NRC Questions

NRC Questions

FLORIDA POWER & LIGHT COMPANY
ST. LUCIE PLANT UNIT 2

OCEAN INTAKE STRUCTURE
FIGURE 291.2-1

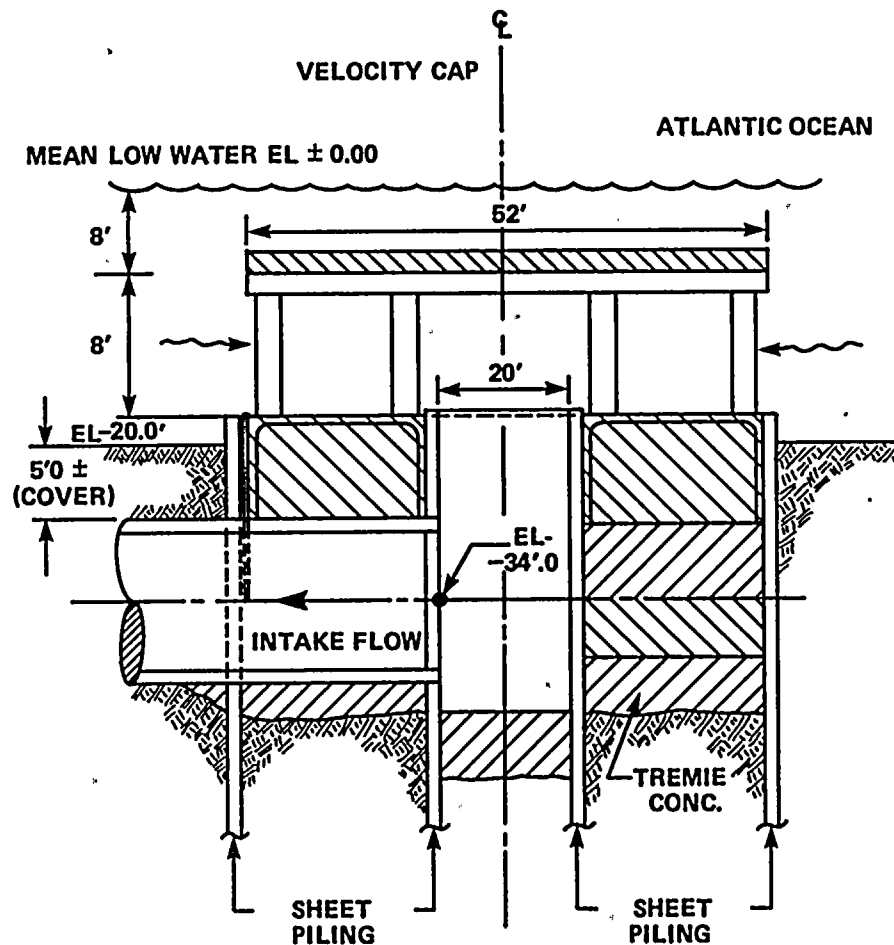
291.2. Describe in more detail the configuration of the velocity cap intake structure. Provide a schematic drawing of the velocity cap, one of more detail than that presented as Figure 3.4-2 in the CP-ER. Provide the free open area dimensions of the ports on the velocity cap and describe any mitigative measures taken to reduce entrainment of organisms in the CWS.

As shown in Figures 291.2-1 and 291.2-2, the velocity cap is an octagonal horizontal concrete slab, 15 inches thick, measuring 52 feet by 52 feet in plan. The cap is supported by 16 concrete columns (eight on the exterior periphery and eight on the interior) which extend from its underside into a 55 foot square concrete base.

Each intake structure has eight rectangular openings. Four of these openings have a width of 24 feet each and the remaining four are 20 feet wide. The depth of each port is eight feet. Gross open area is $[(24 \times 4) + (20 \times 4)] \times 8 = 1408$ sq feet. The net (free).open area is 1246 square feet per cap, after deducting the cross-sectional area for the eight exterior columns. For an ocean water withdrawal rate of 1159 cfs per unit, a net entrance velocity of slightly less than a foot per second will result. The velocity caps at St Lucie Plant were designed with an approximate one fps approach velocity to reduce entrainment of marine organisms.
